**Appendix A –
Responses-to-Comments Table
(Departmental Comments)**

Section 16 Planning Application for Proposed Amendments to an Approved Comprehensive Residential Development Scheme and Minor Relaxation of Gross Floor Area and Building Height Restrictions at Various Lots in D.D. 385 and Adjoining Government Land, Tai Lam Chung, Tuen Mun (Application No. A/TM-SKW/134)

Responses to Departmental Comments

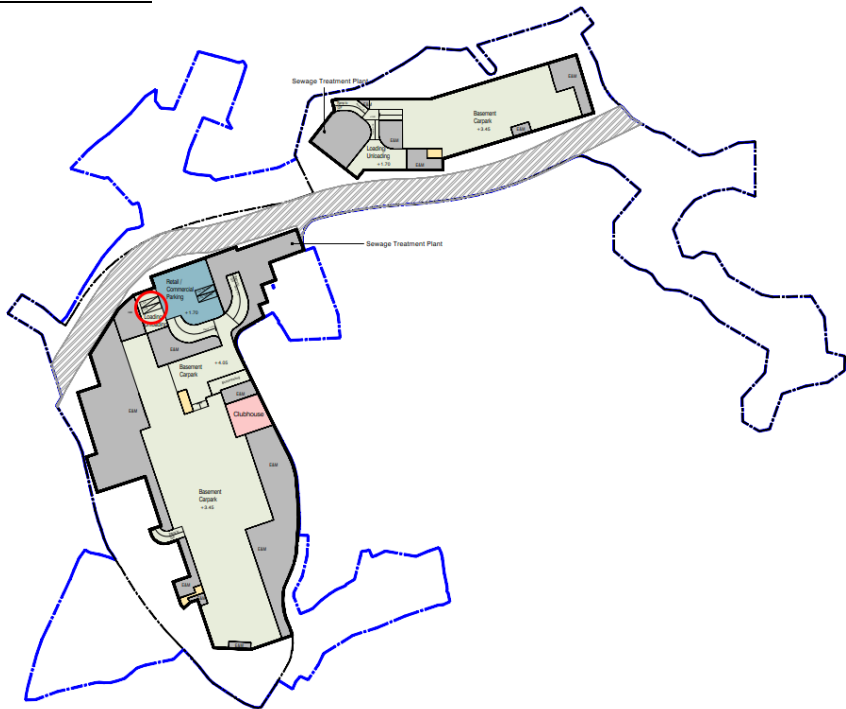
<p>Please note that the implementation programme is indicative only and will be subject to changes as the project progresses.</p>	Timeline	Key Milestones	Year 2025	Approval of S16 Planning Application	Year 2026-27	Processing of Lands Procedures / Lease Modification	Year 2028-30	Construction Works	Year 2030 Onwards	First Population Intake
Timeline	Key Milestones											
Year 2025	Approval of S16 Planning Application											
Year 2026-27	Processing of Lands Procedures / Lease Modification											
Year 2028-30	Construction Works											
Year 2030 Onwards	First Population Intake											
3.4	<u>Traffic Impact Assessment</u> It is noted that the improvement works for Castle Peak Road – Castle Peak Bay was substantially completed in 2024 Q2. Please clarify if the assessment has taken into account such improvement works.	Please be clarified that the relevant improvement works have already been taken into account in the TIA.

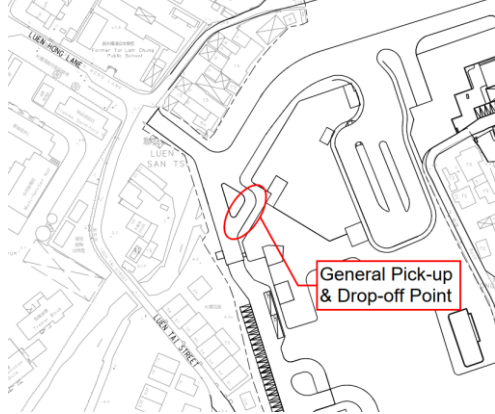
Departmental Comments	Responses to Comments
3.14	As mentioned in the RtoC, the rationale for having a site coverage that is significantly lower than the permissible site coverage under B(P)R (i.e. 22% for above 15m, as compared to 33%; and 47% for below 15m, as compared to 100%) is to allow room and to achieve for design merit including the provision of not less than 7,476m ² of private open space (POS). In this regard, please confirm if the POS and the 30% green coverage are going to be at grade.	<p>While the proposed SC of about 22% (beyond 15m above ground level) and about 47% (up to 15m above ground level) have not yet reached the maximum permissible limits of 33.33% and 100%, it is important to note that a lower SC was proposed so as to allow for the incorporation of various planning and design merits, including provision of additional building separations, and maximizing at-grade private open space as well as greenery provision as far as practicable. To further supplement the above:</p> <ul style="list-style-type: none"> (i) In terms of building separation, it should be noted that two additional building separations of 15m to 25m have been incorporated into the Proposed Scheme as compared to the Approved Scheme. The relatively lower SC under the Proposed Scheme is essential for the incorporation of these additional building separations for breaking down the building mass, enhancing visual permeability and serving as wind corridors and breezeways to facilitate air ventilation; (ii) In terms of provision of private open space, please be advised that the private open space will be provided at grade as far as practicable and/or in locations where they are easily accessible by future residents (i.e. at level not more than 15m measured from the mean level of the abutting streets). To facilitate this, the Applicant has strived to minimise the building footprint of residential towers to accommodate private open space at lower levels wherever practicable; (iii) In terms of greenery provision, please be advised that the greenery coverage (including green roofs) will strictly follow the requirements on Site Coverage of Greenery according to Sustainable Building Design Guidelines, among which not less than 50% of greenery to be located within the Primary Zone. To facilitate this, the Applicant has strived to minimise the building footprint of residential towers to accommodate greenery provision at lower levels wherever practicable.

Departmental Comments	Responses to Comments
		On this basis, the Applicant considers that the current proposal has achieved a reasonable and appropriate balance between utilising SC to manage the increase in BH and minimising SC to accommodate key planning and design merits (including building separations and provision of private open space and greenery at lower levels). Any further increase in SC in exchange for a lower BH would compromise these merits and is considered undesirable from a planning and design perspective. Please be reiterated that the site coverage figures provided, the landscape design and location of private open space are indicative only which will be subject to detailed design.

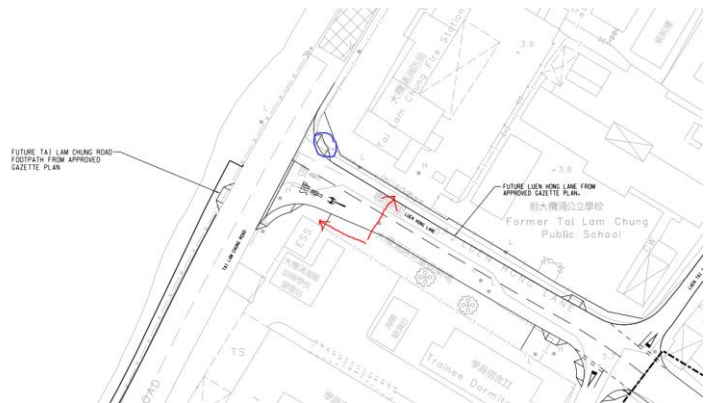
4.2	Table 2.2 – Only 6 L/UL Spaces are identified in Figure 2.1 which is inconsistent to the responses.	<p>Please be advised that 6 nos. of L/UL bays are provided above-ground while 2 nos. of L/UL bays are located at basement. The location of 2 nos. of L/UL bays are indicated below for your reference.</p> <p><u>Basement Floor</u></p>

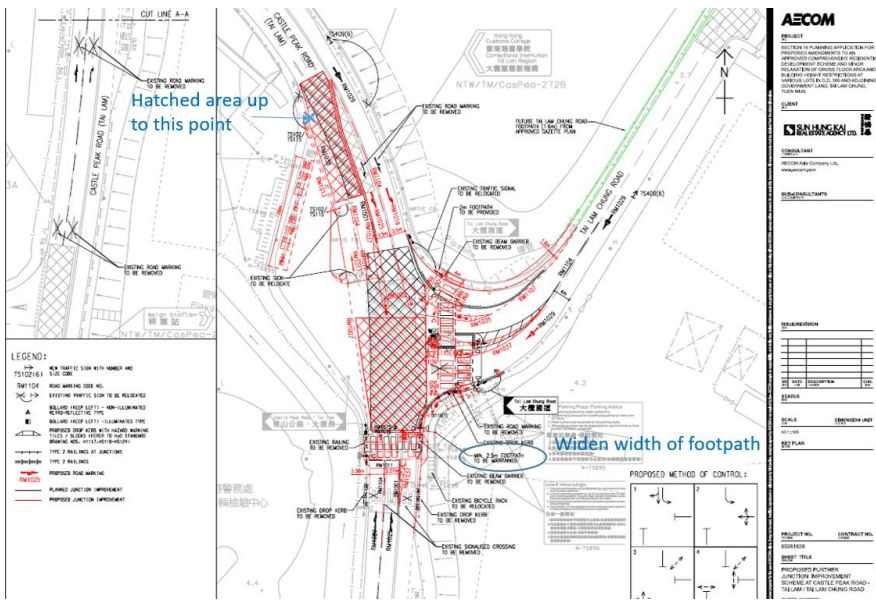
4.29	Figure 2.2 – <ul style="list-style-type: none"> Please provide swept path analysis for 12.8 buses at junction of Luen Hong Lane and Tai Lam Chung Road. It seems that buses at Tai Lam Chung Road N/B right turn to Luen Hong Lane will encroach onto the opposite lane. Please mark all width of proposed carriageway, footpath, pedestrian crossing on the drawing. 	<ul style="list-style-type: none"> Noted. Please refer to SK24 of Annex C of the revised TIA under Attachment 5 for the 12.8m bus swept path analysis at junction of Luen Hong Lane and Tai Lam Chung Road. Noted. The relevant dimensions have been added accordingly. Please refer to Figure 2.2 of the revised TIA under Attachment 5.

Departmental Comments	Responses to Comments
	<ul style="list-style-type: none"> The proposed footpath at road corner encroach onto the area of Tai Lam Chung Fire Station. The consultant should obtain FSD's approval. The southern part of widening of footpath along Tai Lam Chung Road N/B should also be shown on drawing. Cross section showing design width of widening of footpath along Tai Lam Chung Road N/B taking into consideration of railings and beam barriers should be provided in the TIA. Please review if an additional pedestrian crossing could be provided as shown in red arrow below. Sightline at proposed pedestrian crossing at Luen Hong Lane near Tai Lam Chung Road will be obstructed by the existing fence wall of Tai Lam Chung Fire station (location shown in blue below). Please review and revise. 	<ul style="list-style-type: none"> Noted. Noted. The drawing has been revised accordingly. Please refer to Figure 2.2 of the revised TIA under Attachment 5. We acknowledge the concerns regarding the street furniture arrangement. Please note that the details will be further reviewed with relevant government departments in detail design stage accordingly. We acknowledge the concerns regarding the location of the proposed pedestrian crossing at Luen Hong Lane near Tai Lam Chung Road. Please note that the details will be further reviewed with relevant government departments in detail design stage accordingly. Ditto.

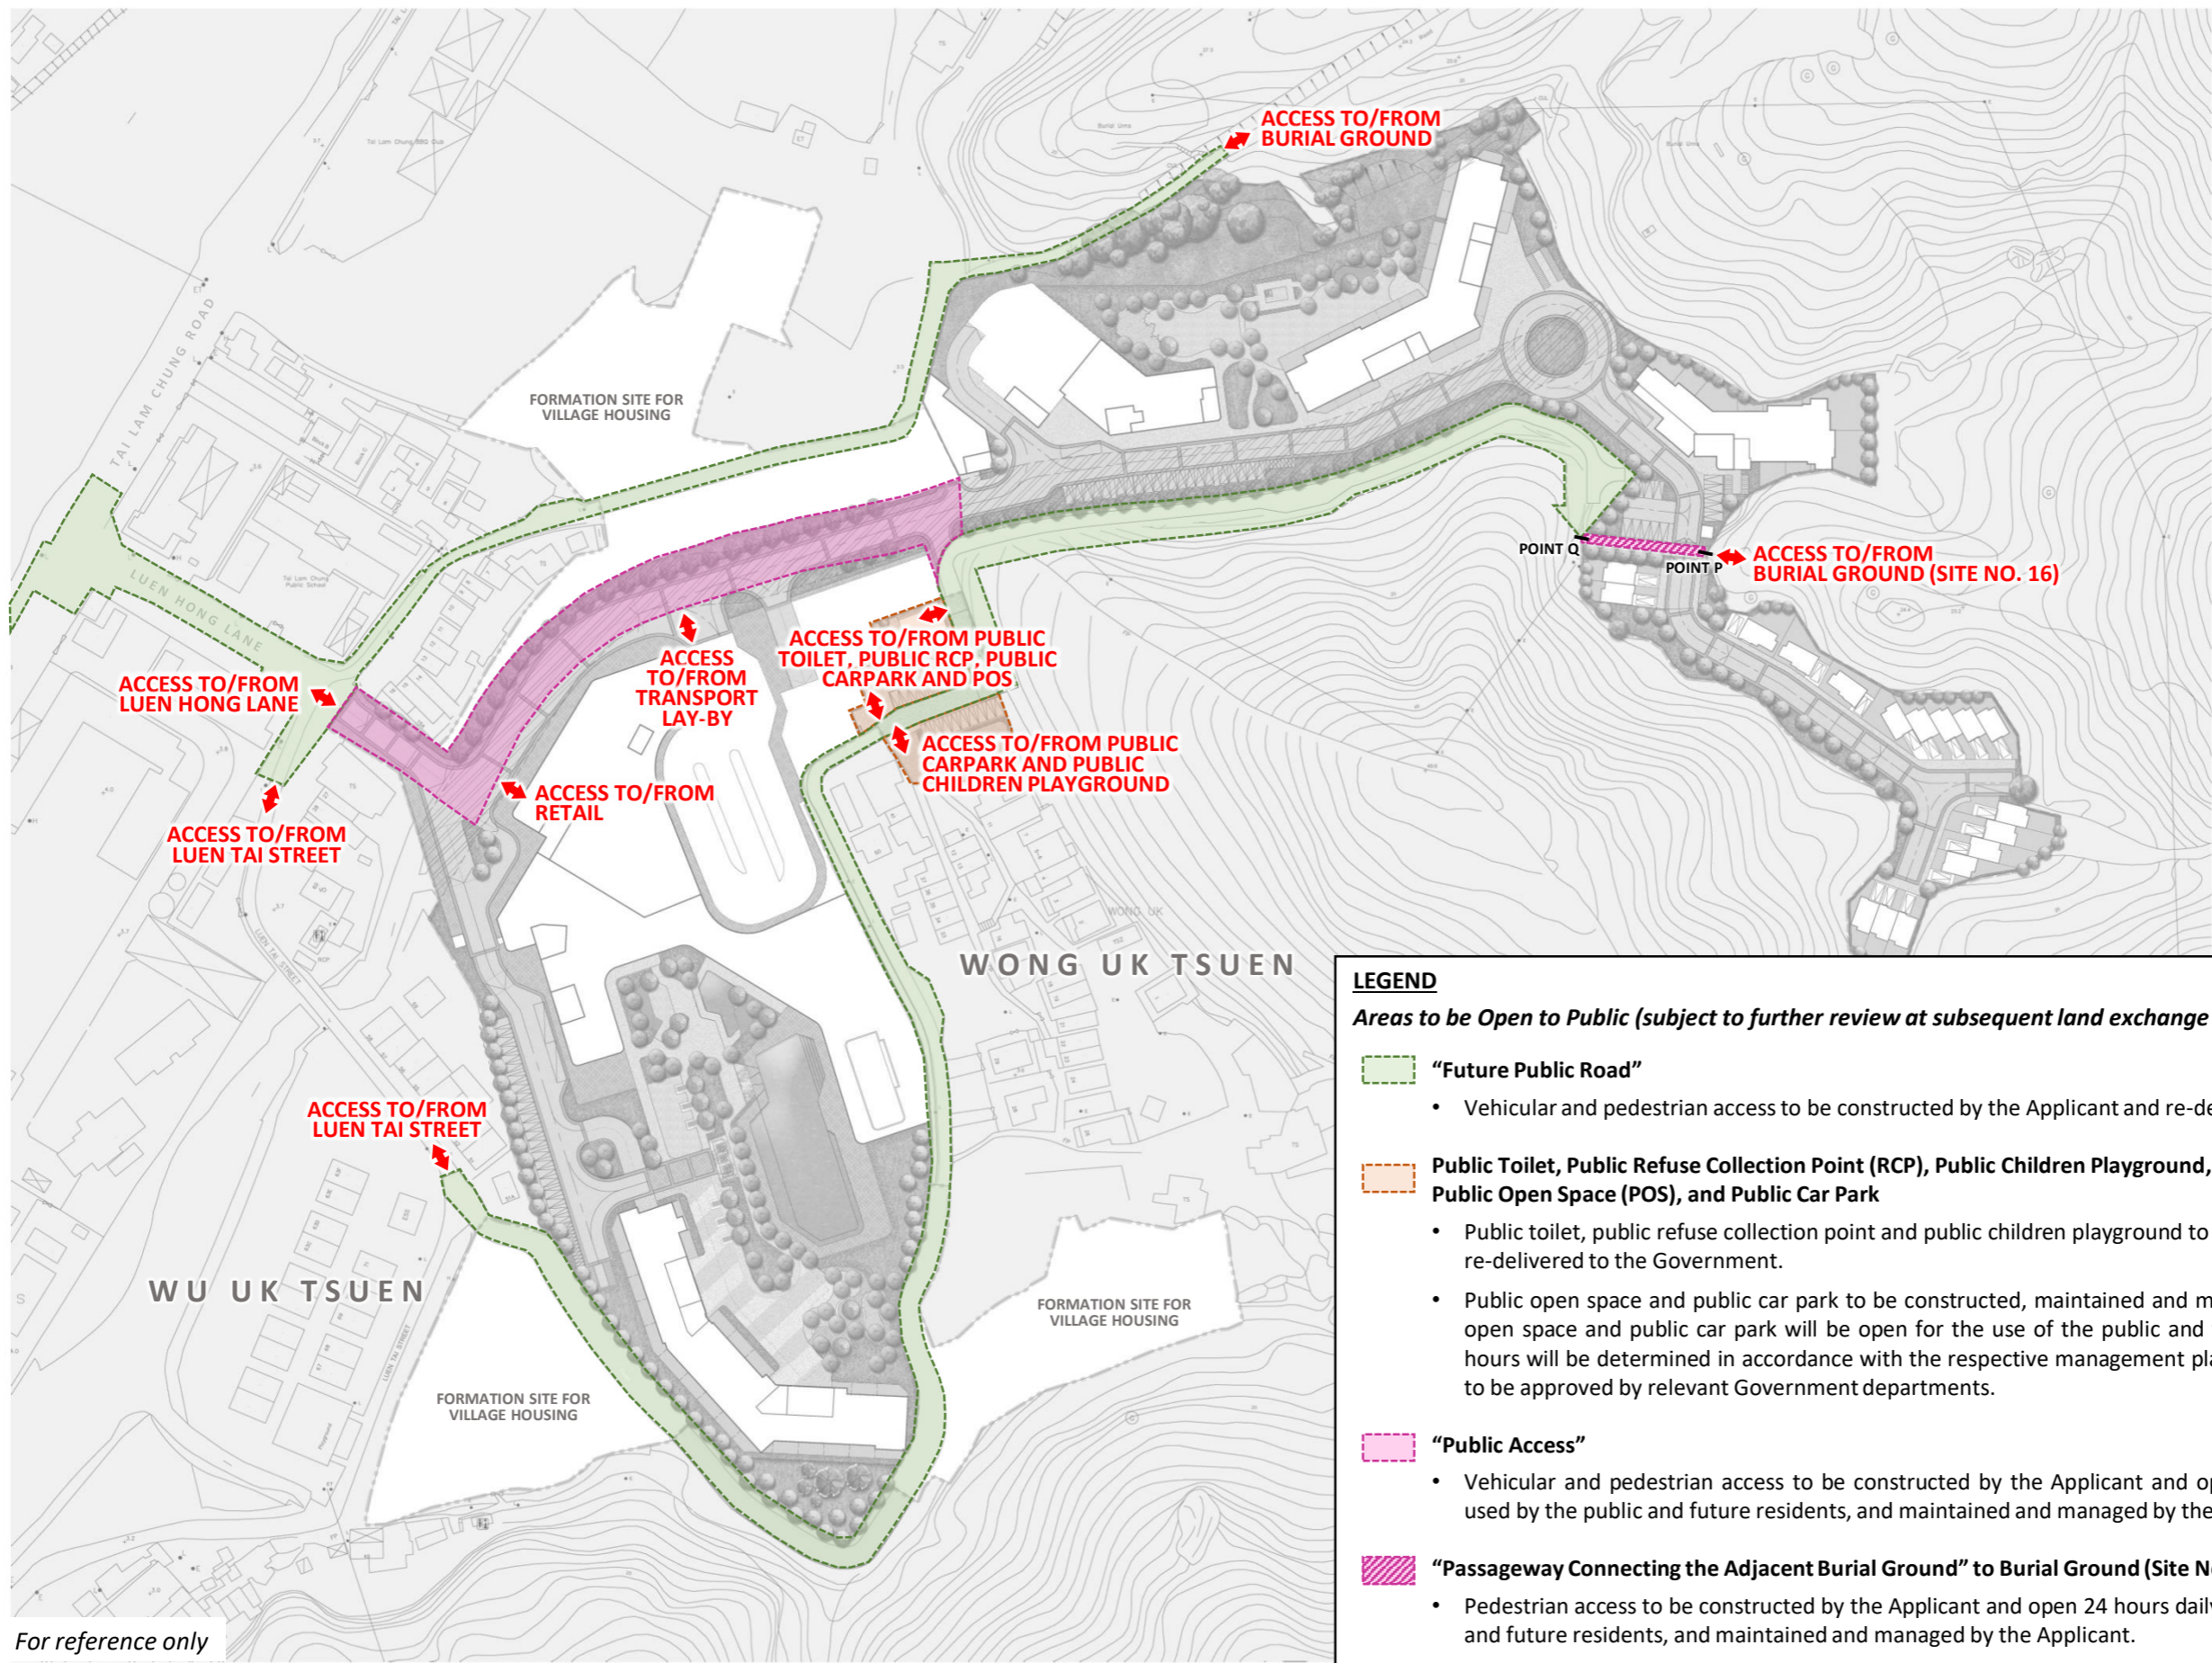
4.49	<p>Section 4.2 - According to Sections 4.2.1 and 4.2.2, it is proposed to introduce 14 trips between the Development and Tuen Mun Road Bus-Bus Interchange (“TMRBBI”) during peak hours, which contradicts with the proposed public transport plan in Sections 4.2.5 and 4.2.6.</p>	<p>Noted. The typos in Table 4.2 of the revised TIA under Attachment 5 have been revised accordingly.</p>

Indicative Access Arrangement Diagram

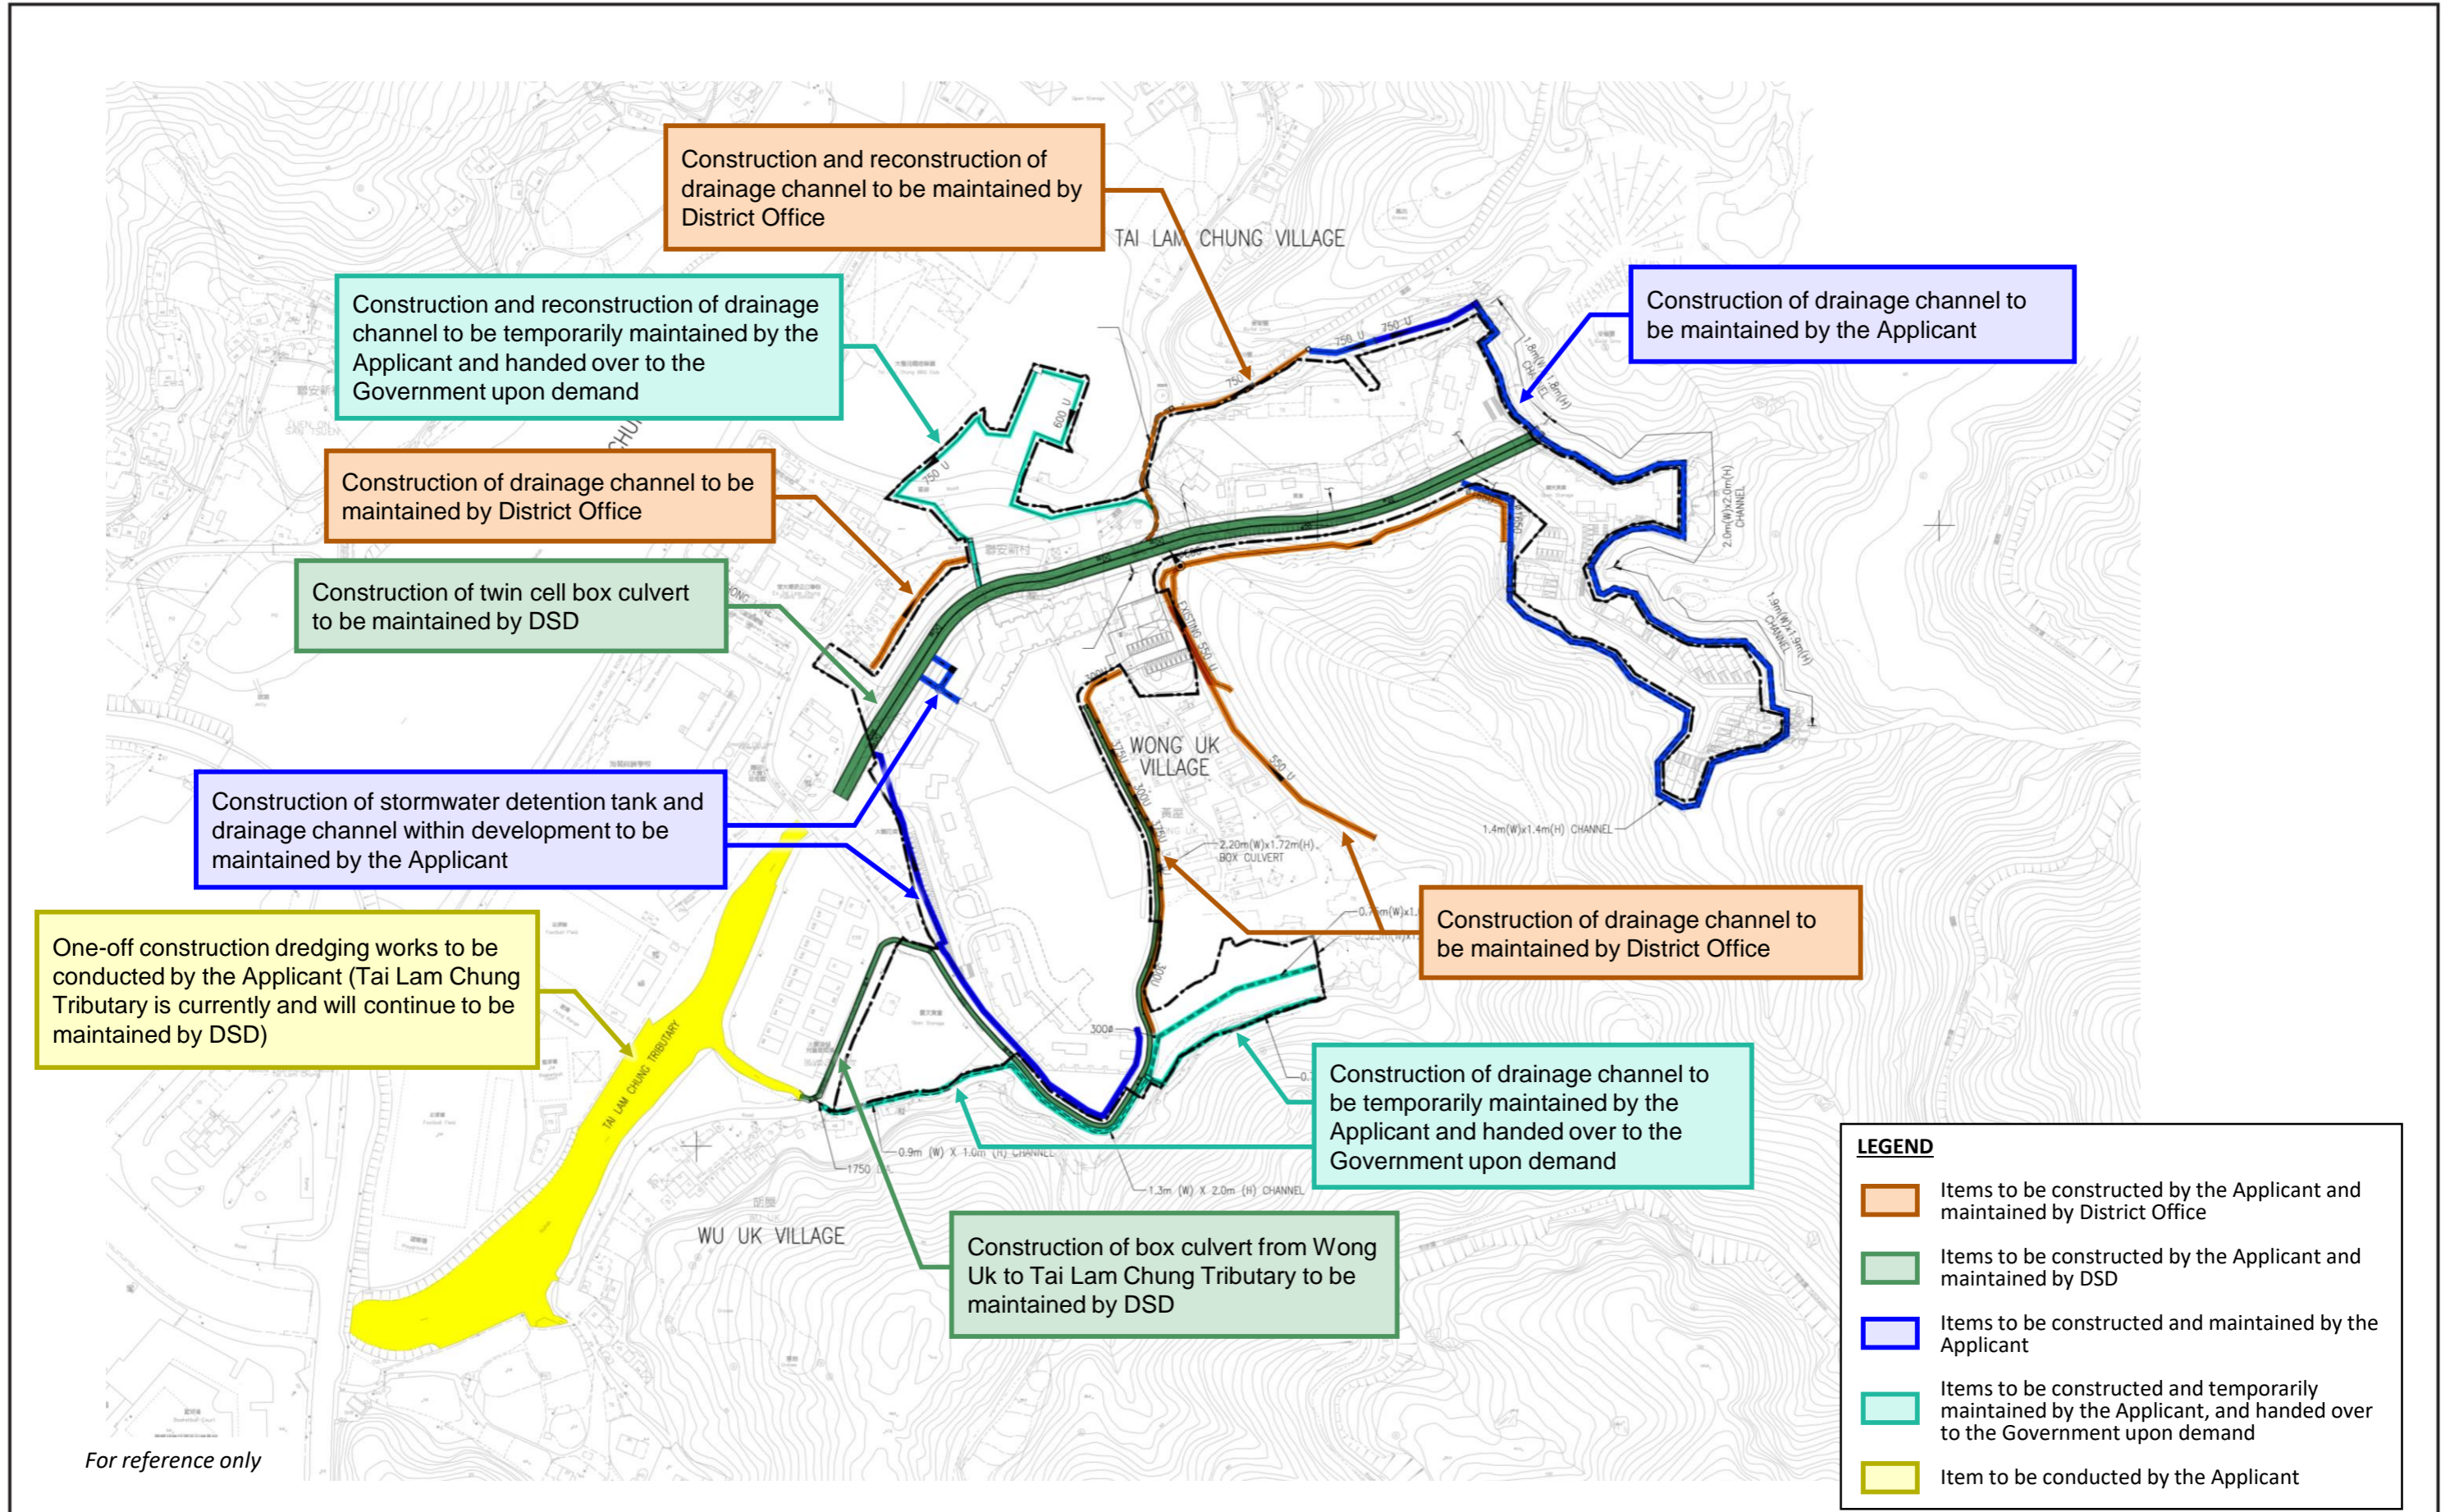
Departmental Comments	Responses to Comments
4.	Comments of Transport Department	
	<u>Traffic Engineering Perspective – Comments on 30.9.2025</u>	
4.1	From the swept path analysis SK10 and SK12, it seems that PC may not be able to enter Luen Tai Street from Luen Hong Lane when another vehicles is waiting at the give way lines on Luen Tai Street. Please review the junction and road marking layout.	The junction layout of Luen Hong Lane/Luen Tai Street has been further reviewed and revised. Please find the updated swept path analysis in the revised TIA under Attachment 5 .
